Origination Form
Proposed Revisions to a Standard Plans Index

Originator:	Turley, Joshua	Index Number:	400-091
Date:	5/15/2025	Sheet Number(s):	Sheet 2
E-mail:	Joshua.Turley@dot.state.fl.us	Index Title:	APPROACH SLABS (30 FT.) (RIGID PAVEMENT APPROACHES)

NEW Notes Section Notes:

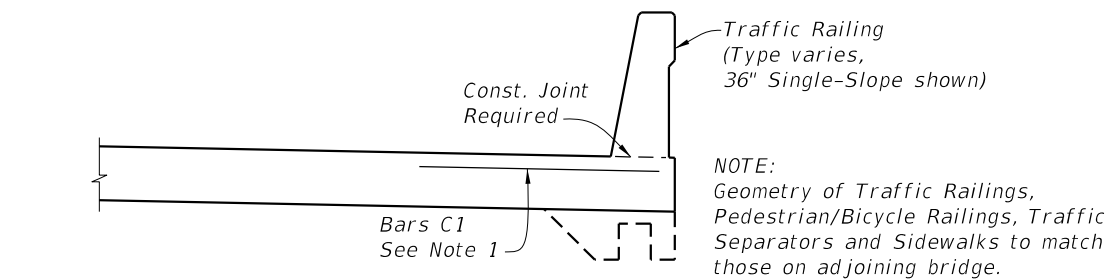
Moved to NEW Note 2

- 1.
- 2.
3. Expanded Polystyrene 1" min. top for MSE walls, 3" min. top for rigid retaining walls. 1/2" each side.

SECTION THRU APPROACH SLAB
AND RETAINING WALL

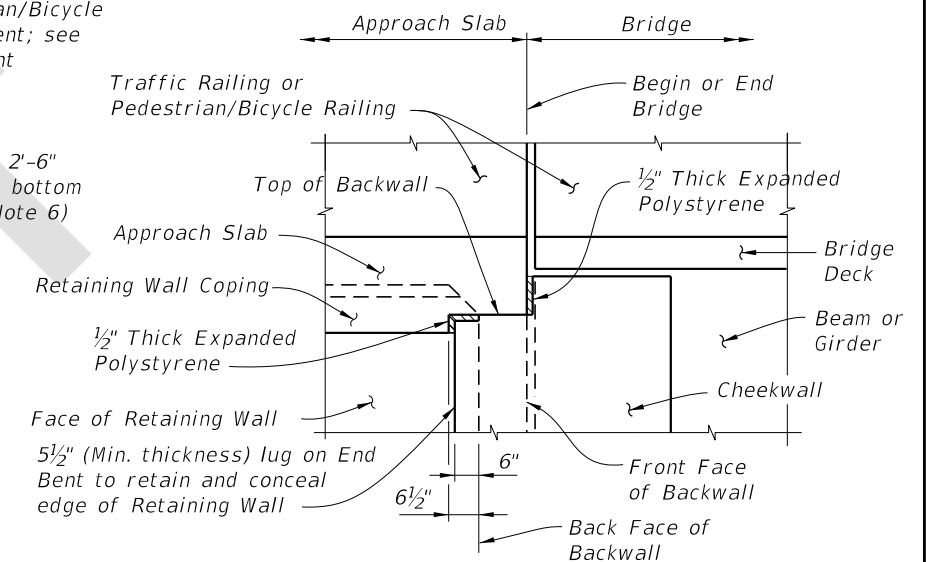
Sheet 2: Converted starred notes to numerical notes. Adjusted the coping embed requirements for the top of the retaining wall in SECTION THRU APPROACH SLAB AND RETAINING WALL.

Contractors had trouble meeting top-of-wall elevations for MSE walls due to settlement issues. When predicted settlement didn't occur, walls were too high and required sawcutting. To address this, minimum thickness and embedment requirements for Expanded Polystyrene were relaxed, allowing better control over final wall elevations.

1. Bars C1 are required as shown when the 36" or 42" Single-Slope Traffic Railing, or the Traffic Railing/Noise Wall, are used at the edge of the Approach Slab.
2. Actual location & width vary depending on type of Retaining Wall used.
3. Expanded Polystyrene 1" min. top for MSE walls, 3" min. top for rigid retaining walls. 1/2" each side.
